Planning & Zoning Commission Regular Meeting

Wednesday, March 12, 2025 at 6:30 PM

- 5. Consideration, discussion, and possible action on a Subdivision Preliminary Plat for Manor Commons NE Commercial being 19 (nineteen) lots on 31.889 acres, more or less, and being located at the northeast corner of the intersection of US HWY 290 and FM 973 Manor, TX.**

The first submittal of the Manor NE Commercial Preliminary Plat (*Preliminary Plan*) submitted by ALM Engineering, Inc. and received on January 22, 2025, have been reviewed for compliance with the City of Manor Subdivision Ordinance 263B.

POND CROSS SECTIONS

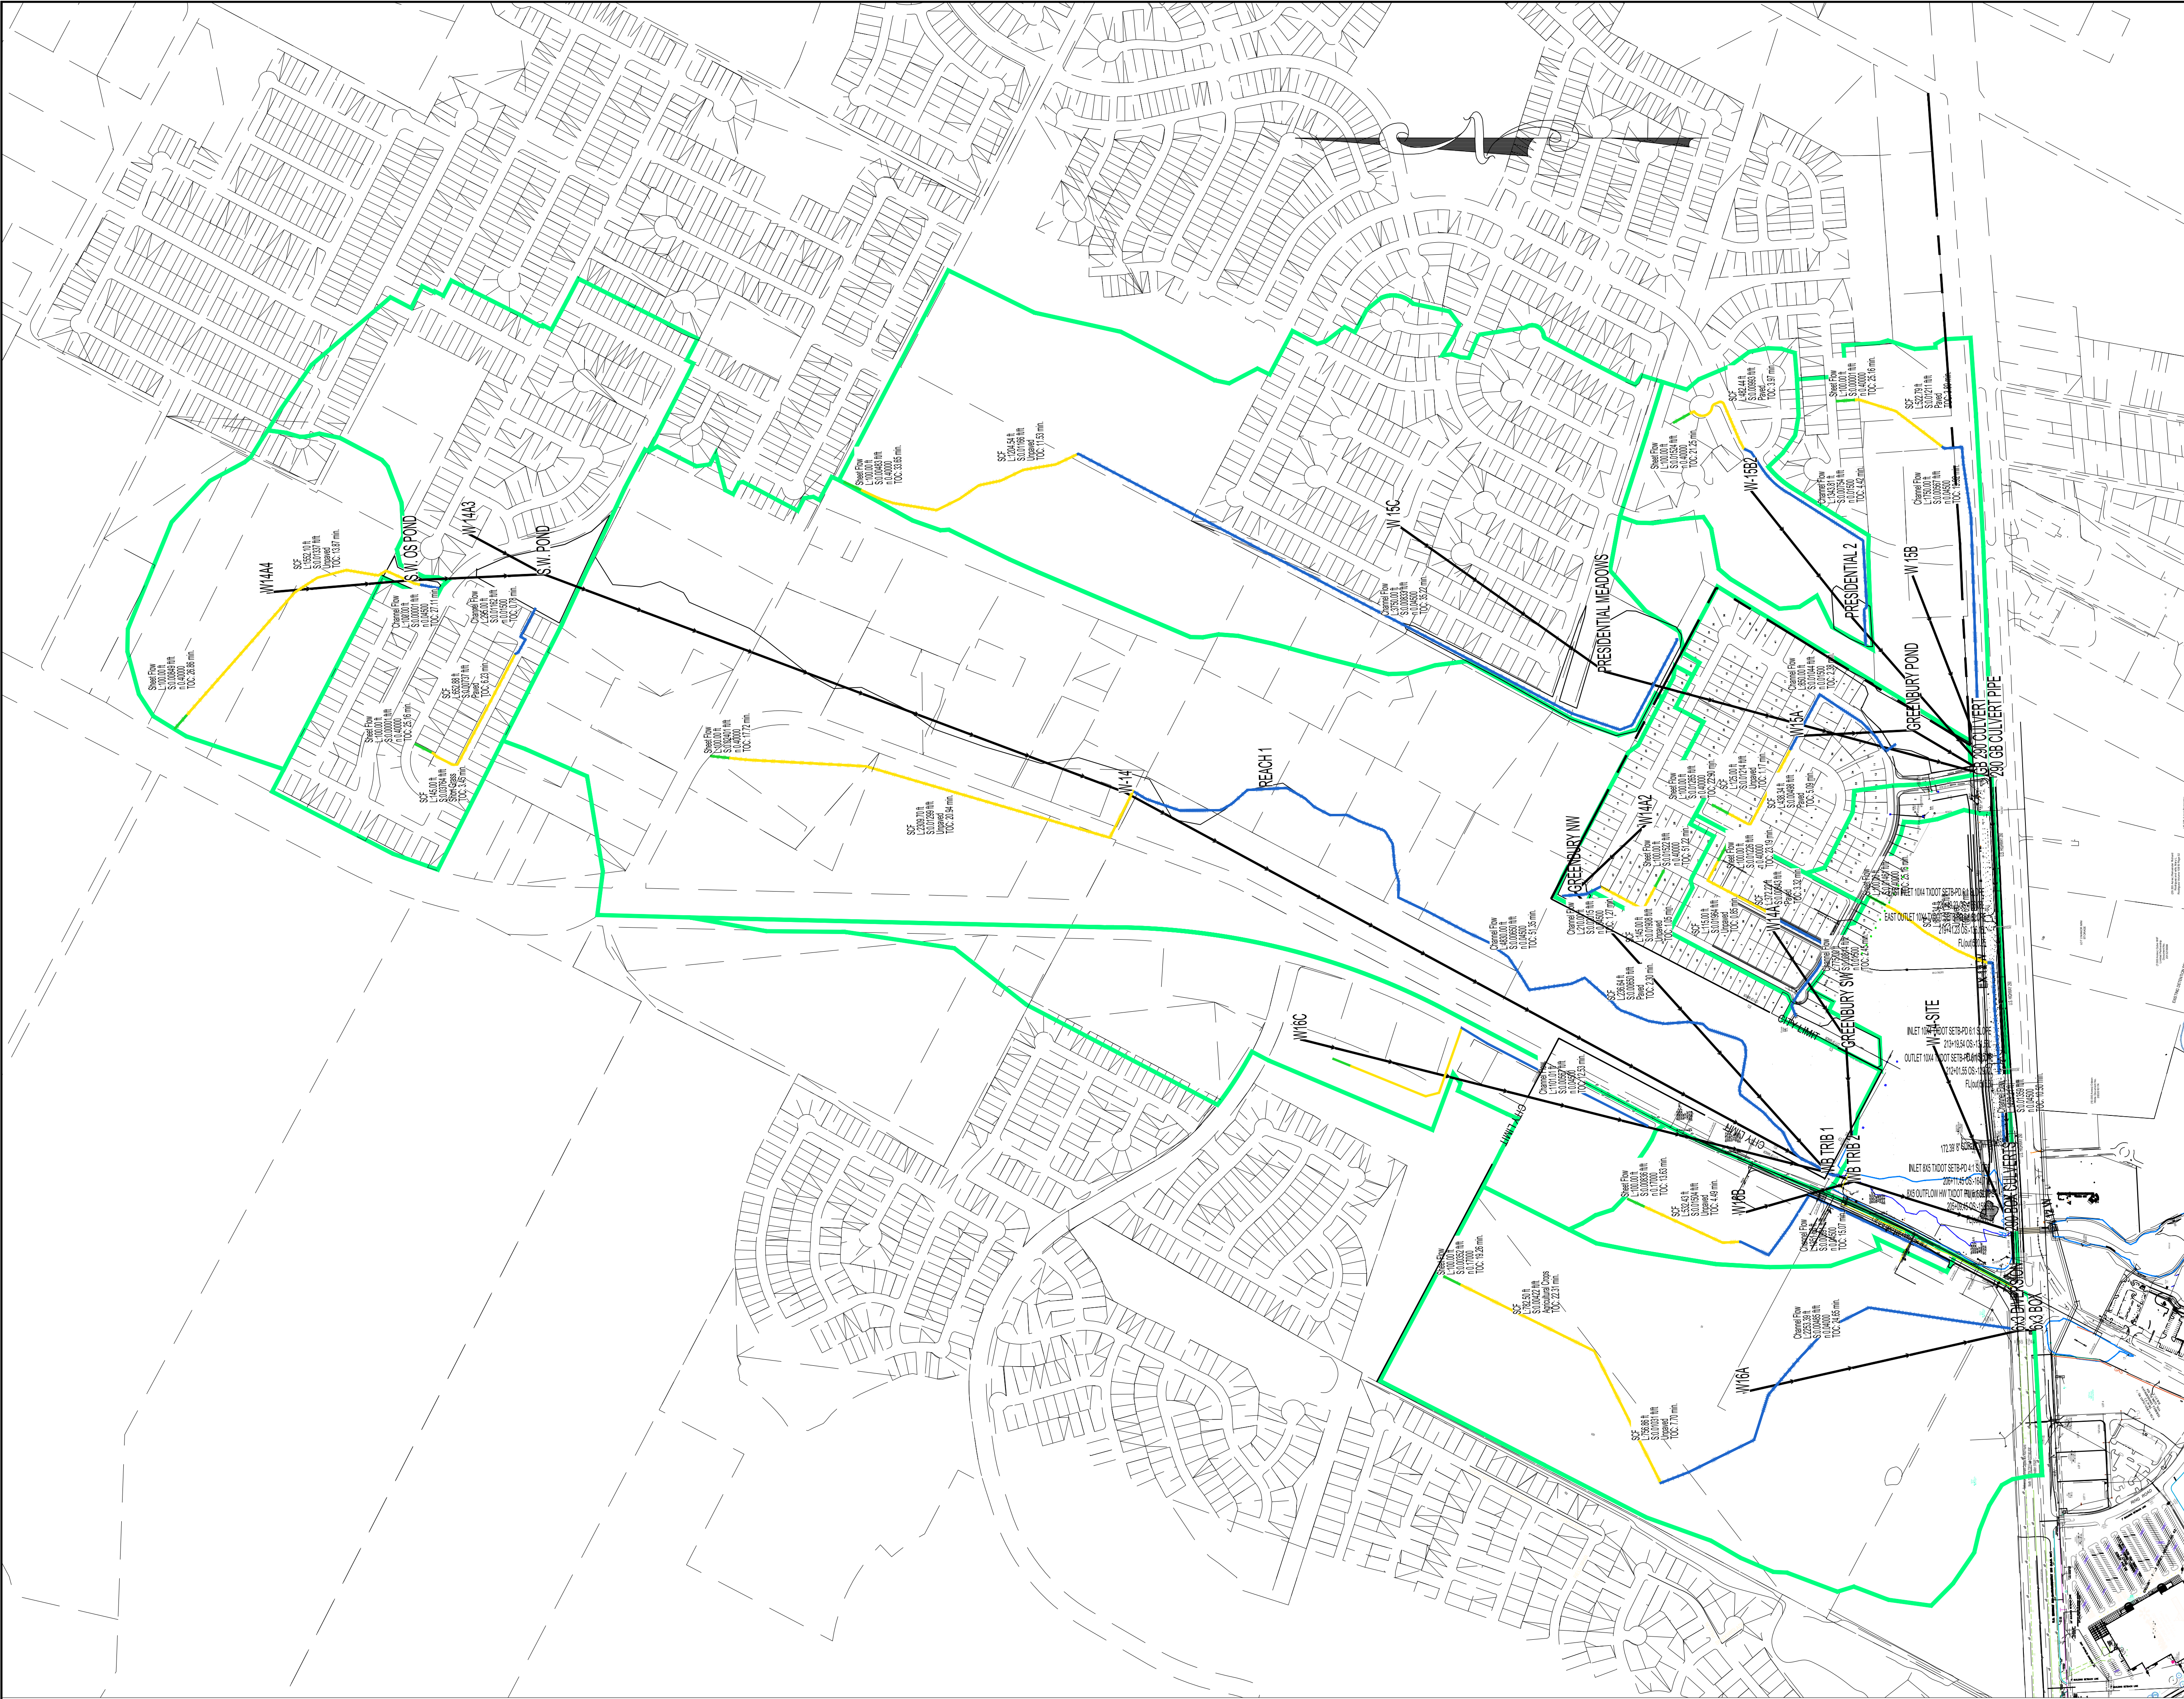
xiii. Callout the top of the ponds outflow wall elevation. Verify that the 100-year storm water level elevation does not exceed this.

RESPONSE: Labels have been added to the cross section views of the pond to indicate the top of the pond wall. The 100-year event is fully contained in the pond.

PROJECT NO. 1168-001-24
DRAWING NO. _____
SHEET 8 OF 31

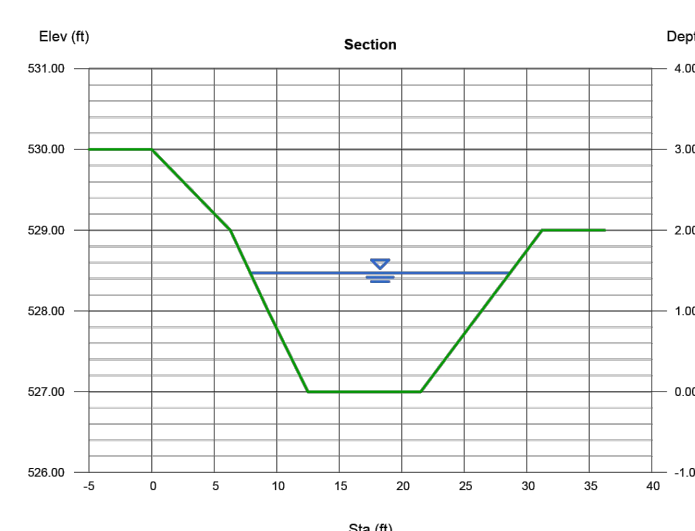
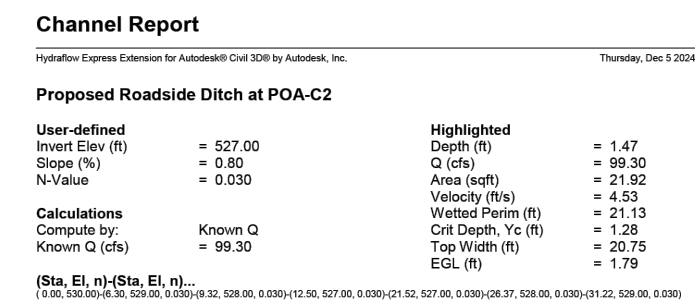
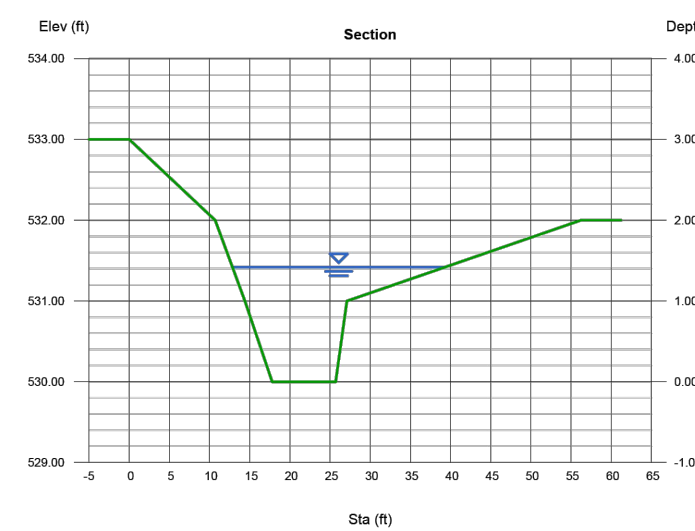
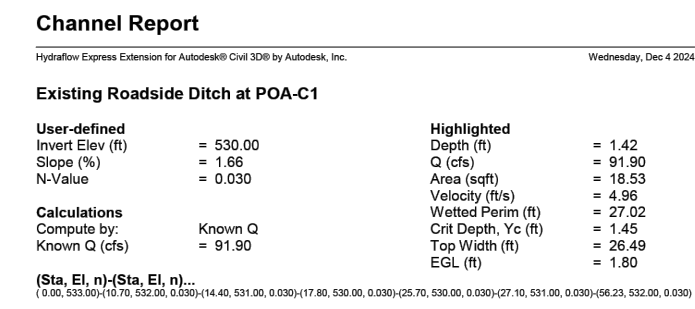
5. On the proposed Drainage Area Map (Sheet 8 of 30), clearly show the proposed storm sewer line. Currently, everything looks in gray scale and it is difficult to distinguish between existing and proposed infrastructure.

Comment Response: The proposed storm sewer line is now more prominent and shown darker on the Proposed Drainage Area Map (Sheet 8).
